DESIGN CHANGES

Project Name County Flats, Sandfields
Project Ref OAD_5174
Drawing Ref 1210
Drawing Name Flat Type C01
Drawn By WS
Date 15.04.2021

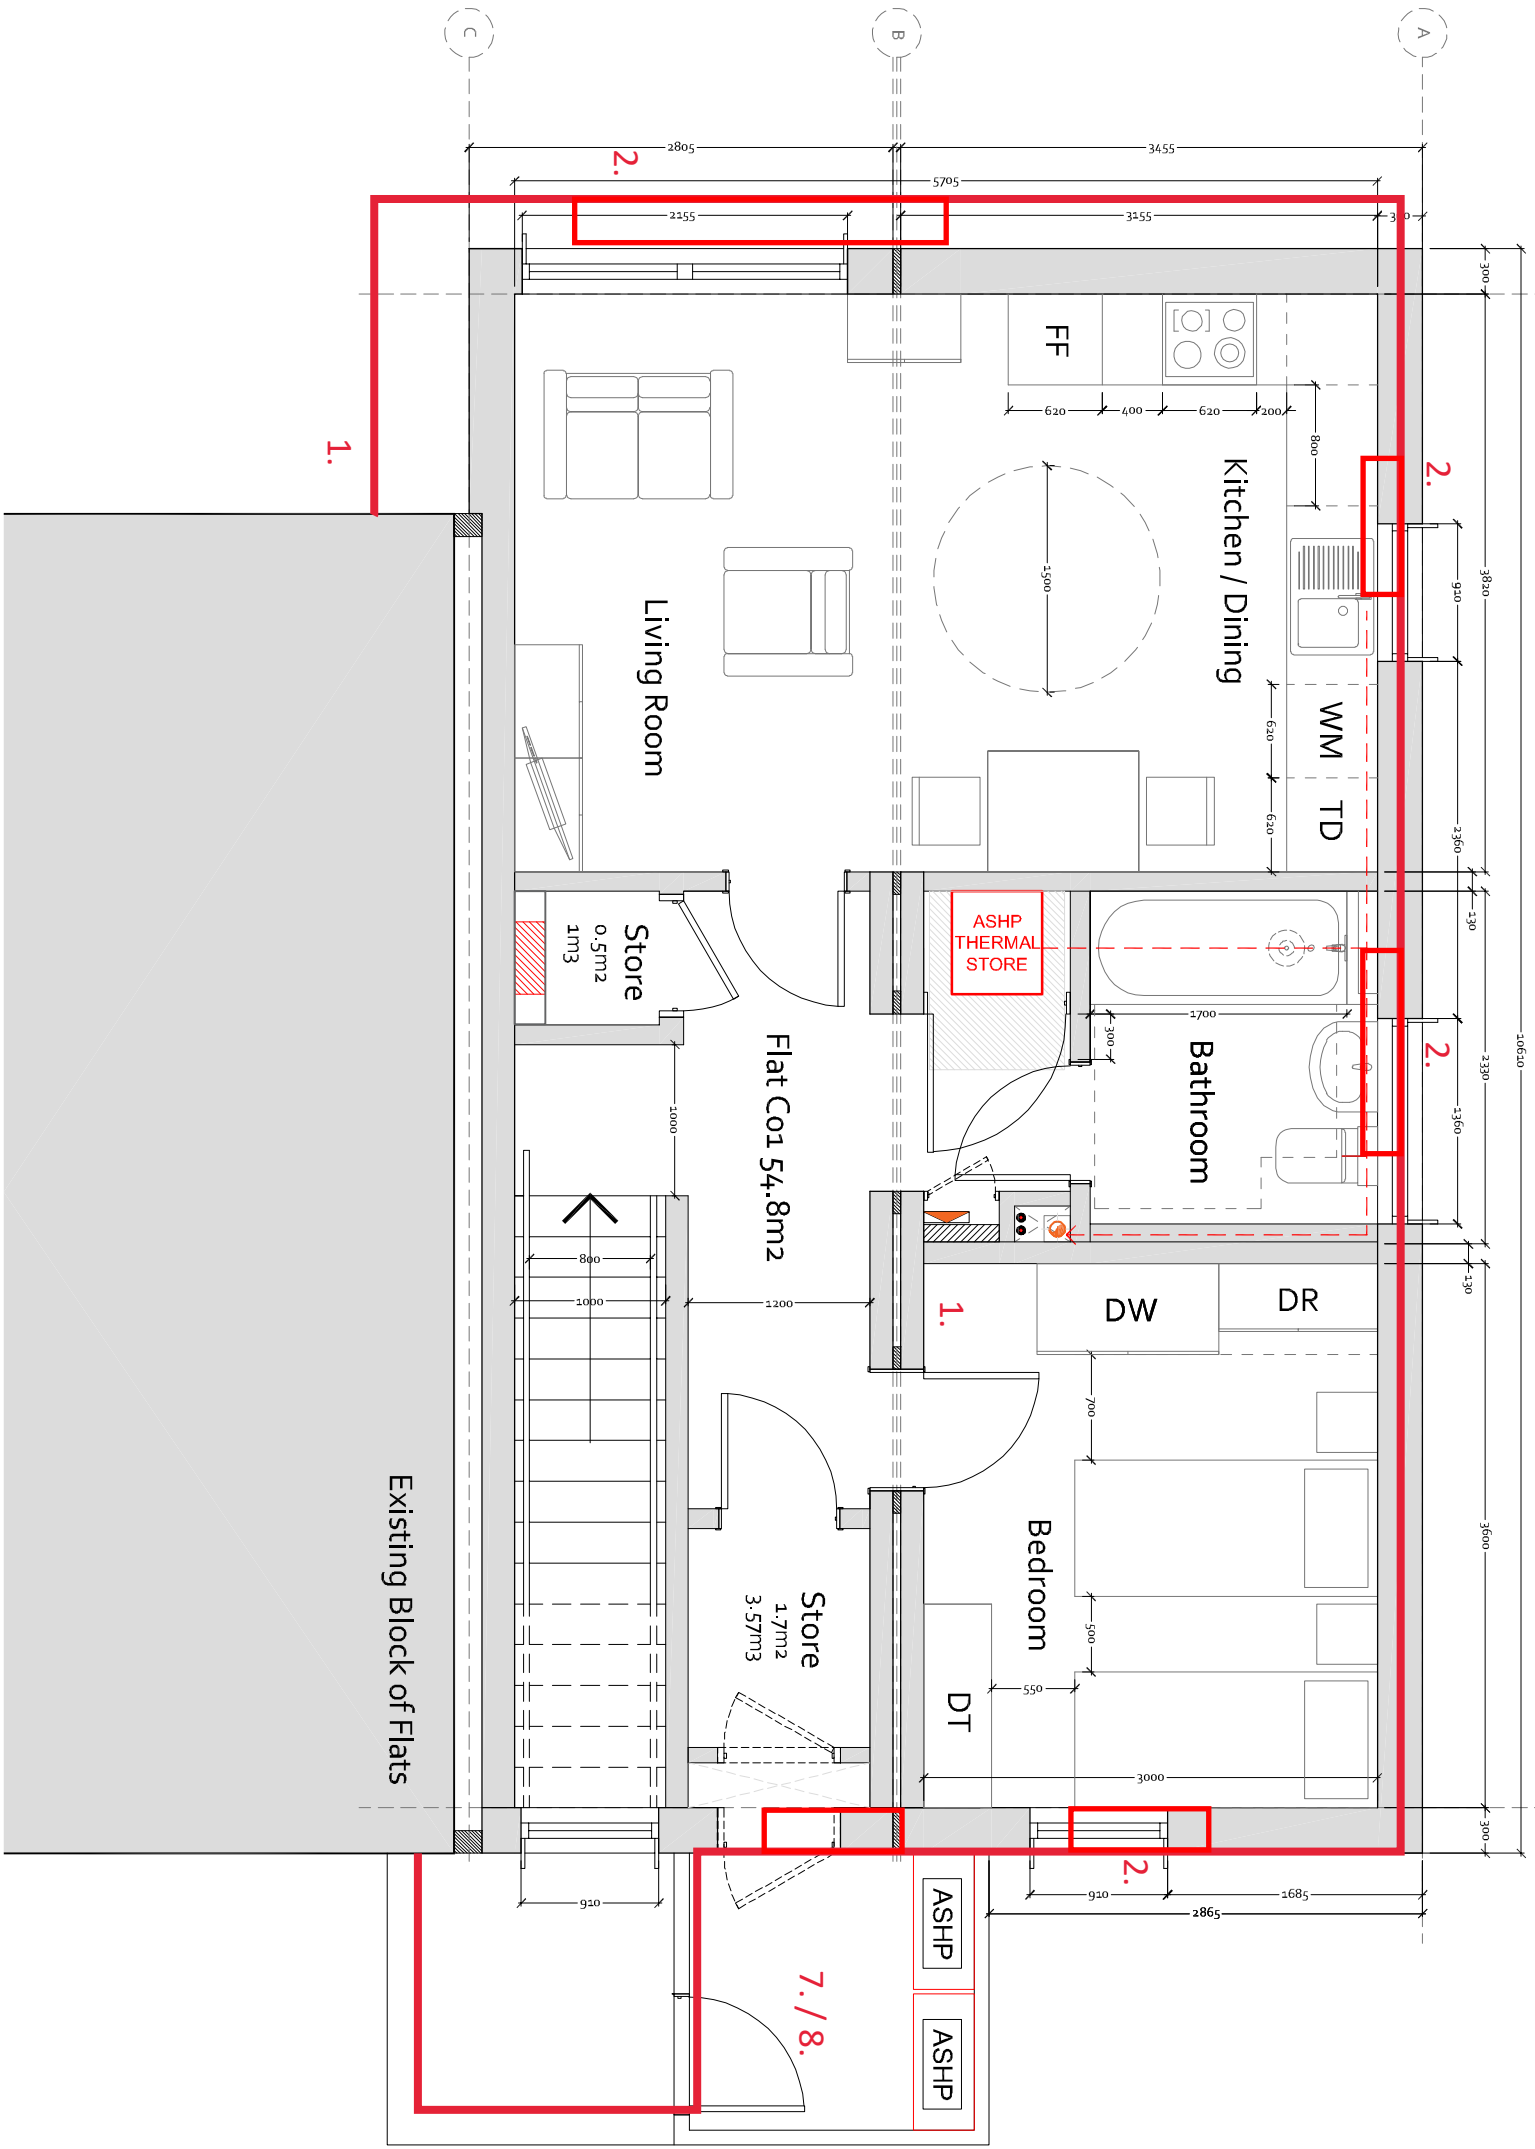
1. Modular end links re-positioned slightly off existing buildings, with the party wall straightened and porch projections aligned with this wall, to ensure modular construction can be achieved off site.
2. Windows have been slightly re-positioned to the new build to suit the structural design of the modular units and the constraints of the timber frame.
3. Parapet to modular end blocks have been lowered by approx 900mm to comply with the structural wind loadings and timber frame design.
4. Corner windows have been removed and replaced with 2no. Windows on either corner, again due to the structural and timber frame design of the blocks.
5. PV panels have been omitted from the end modular units to suit the structural and timber frame design of the blocks.

6. Ground floor Juliet balcony added to existing flats to provide better security whilst ensuring the open areas remain as communal spaces.
7. Air source heat pump external louvre enclosure amended to be single storey over entrance canopy to end link blocks.

8. External air source lowered enclosure handed to provide internal riser/access requirements for maintenance.
9. Buggy/cycle store added to block 6 and 7 parking courtyards.

10. Bin stores slightly re-positioned to suit existing drainage runs, with bin store near block 6 amended in size to suit located of bedroom window.
11. Footpaths amended to be Tarmac.

12. Windows in communal area to the linked blocks made narrower to ensure 1.8m fire separation distance to existing windows is achieved to comply with building regulations.

13. 1no. window in block 7 communal area either side of stairwell removed to ensure 1.8m fire separation distance to existing windows is achieved to comply with building regulations.
